**Re: Initial Submission Review – Prologis Park 70 NO1 - Sign Adjustment**  
Application Number: **DA-1396-17**  
Case Numbers: **2012-6025-01**

## *Initial Submission Review*

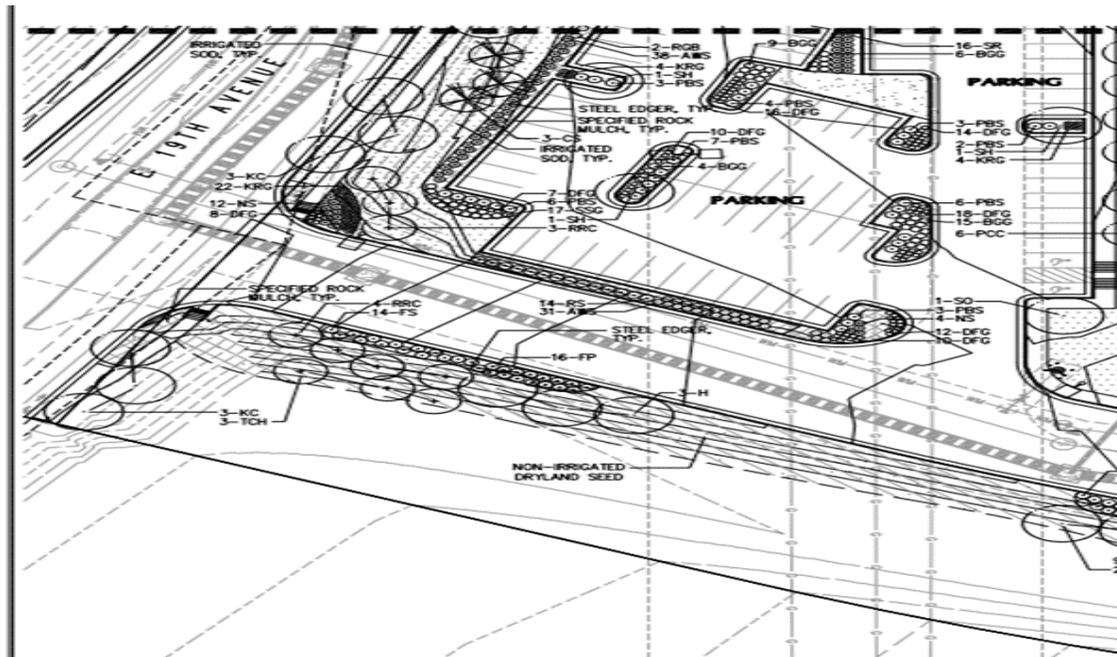
- 2A. Please use the approved Site Plan “Entry & Open Space Park 70 Site Plan” and include your Alia/ ACSM Land Title Survey to the Site Plan after page L6.
- 2B. The maximum height of monument signs shall not exceed 8 feet, and the maximum size of the sign shall not exceed 100 square feet per sign face.
- 2C. Please update your Letter of Introduction and justify the adjustment per the adjustment criteria in section 146-5.4.4.3.D <https://aurora.municipal.codes/UDO/146-5.4.4.D.3>.
- 2D. Please provide an approval letter from the Prologis Architect committee. (Tom Marko).
